## Crown Sydney - Response to Submissions

The following document provides responses to issues raised in relation to the transport study supporting the Crown Sydney development application.

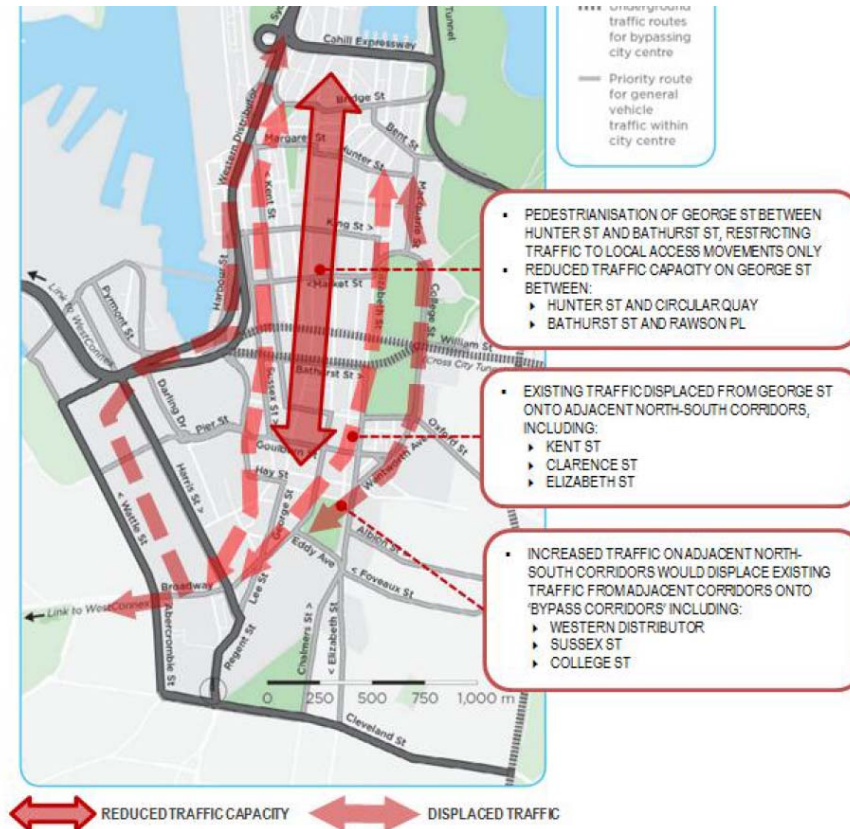
***The proposed changes to George Street as a result of the proposed CBD Light Rail will increase traffic movements on the road network located within and adjacent to the Barangaroo Precinct. These changes have not been taken into account within the traffic analysis for the proposed development***

As noted in the TMAP, Transport for NSW is currently preparing a meso-scopic traffic model which considers the impacts on CBD streets following the completion of the Sydney light rail project. The EIS for the light rail project (specifically Technical Paper 1 – Transport Operations Report) provides no specific details with respect to changes in traffic volumes on Hickson Road adjacent to Barangaroo following the closure of George Street to general traffic.

It should be noted that the Sydney City Centre Capacity Improvement Plan (RMS, November 2014) provides some detail with respect to the redistribution of traffic following the closure of George Street to general traffic. This plan illustrates the existing traffic displaced from George Street will be redirected onto adjacent north-south corridors, those being:

- Kent Street
- Clarence Street
- Elizabeth Street
- Macquarie Street

Capacity improvements along both Clarence Street and Kent Street are proposed which are forecast to mitigate the impacts of this redistributed traffic.

Importantly Hickson Road and Sussex Street (at the northern end of the CBD) are not identified as corridors expected to take displaced traffic from George Street. Therefore the traffic flows used for the modelling in the TMAP are considered appropriate to understand the impacts associated with the proposed development.

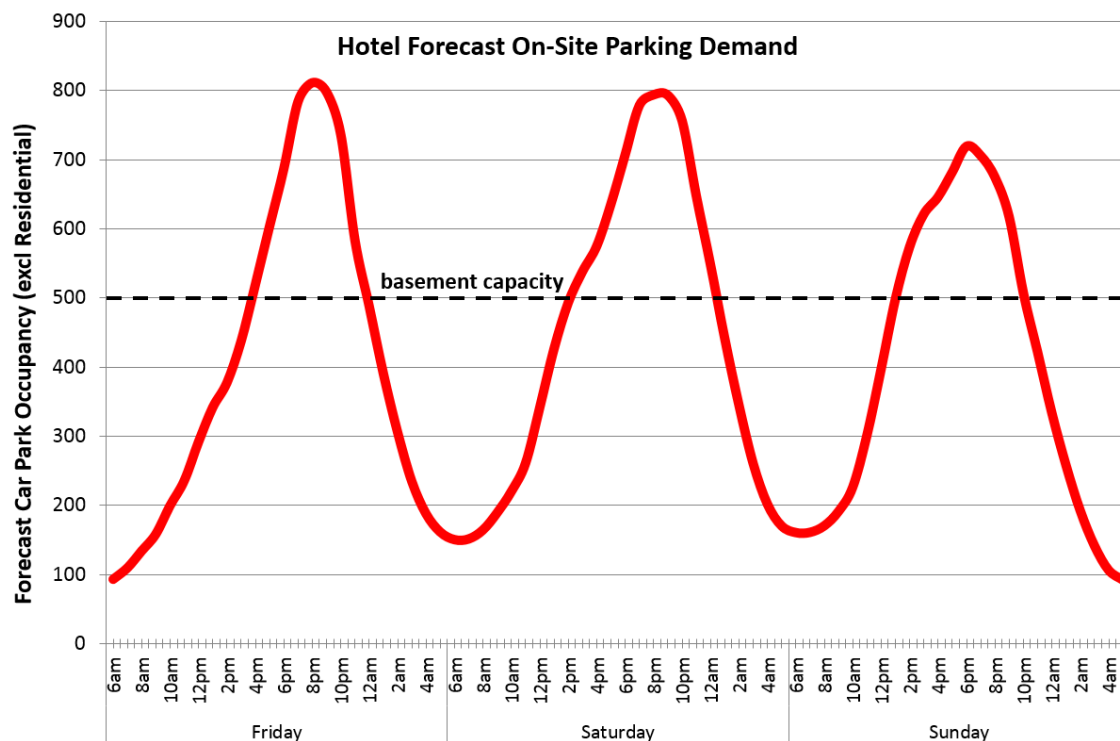
***Several construction projects are likely to occur at the same time within the Barangaroo and Wynyard Precincts. The cumulative increase in construction vehicle movements from these projects could have the potential to impact on bus services in the CBD, and the safety of pedestrians and cyclists within the Barangaroo and Wynyard Precincts during commuter peak periods***

A cumulative traffic assessment has been undertaken which considers the impacts of the Crown Sydney construction project in the context of ongoing works within the Barangaroo and Wynyard precincts. This assessment concludes the Crown Sydney construction works will have a negligible impact on the operation of the road network compared to the current environment.

The assessment also considers pedestrian and cyclist movements during the construction works. The assessment concluded the construction related impacts, particularly with respect to pedestrians and cyclists, could be appropriately managed.

No footpath closures or changes to existing bicycle routes are considered necessary to facilitate the construction works. The pedestrian environment in the Barangaroo/Wynyard precinct has recently been improved through the opening of the City Walk Bridge and installation of traffic signals at the Hickson Road / Napoleon Street intersection. The pedestrian network will be further enhanced following the opening of the Wynyard Walk Bridge – expected in late 2015.
